BULLETIN NO. 112105

TITLE: Burner Tube Change

MGB 50 thru 300	Nat and LP gas	Spark and std. pilot
------------------------	----------------	----------------------

Photo 1

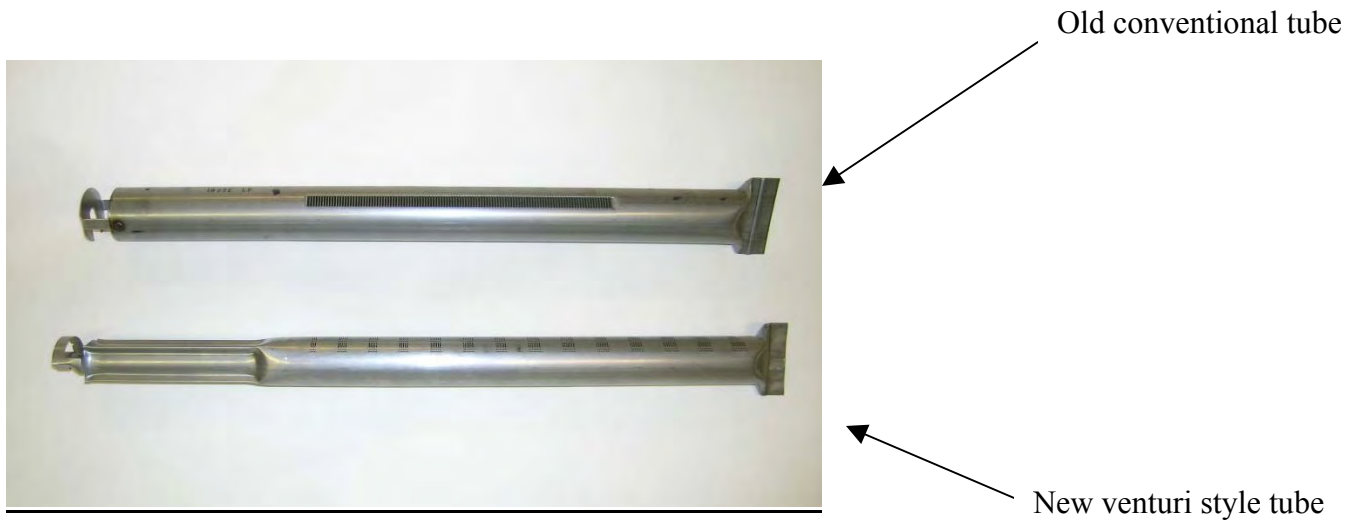
The current burner tubes used on the MGB-series Utica Boilers have been obsoleted and replaced with a new style burner of advanced design (see photo 1). The new burners were designed for quiet operation and better performance under harsh field conditions, i.e. L.P. Gas.

The new style tubes, part no. **240005543** are a direct replacement for the old style tubes on the MGB50 thru 250 and require no burner door change.

Photo 2

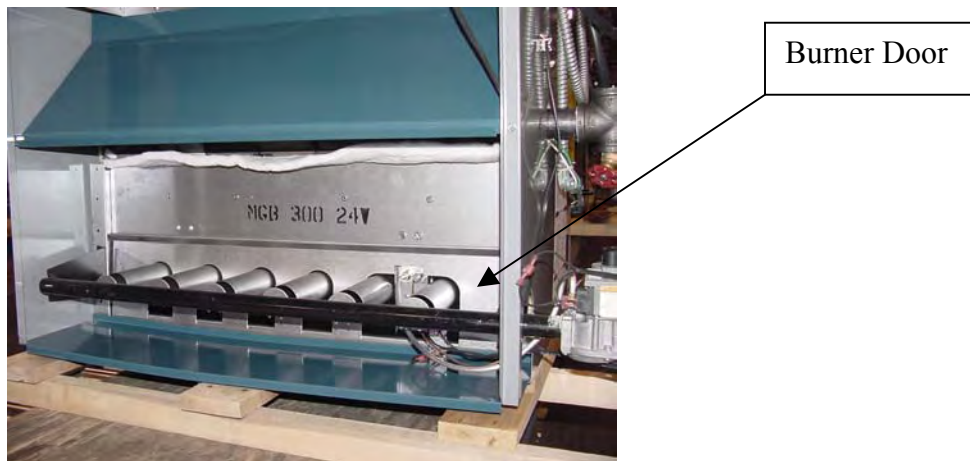
The MGB300 requires a slight change to the burner door to accommodate the new tubes. Kit no. **550001347** is to be used in the event the new tubes are used to replace old style tubes in the field. This kit includes a new burner door along with the new burner tubes (see photo 2).
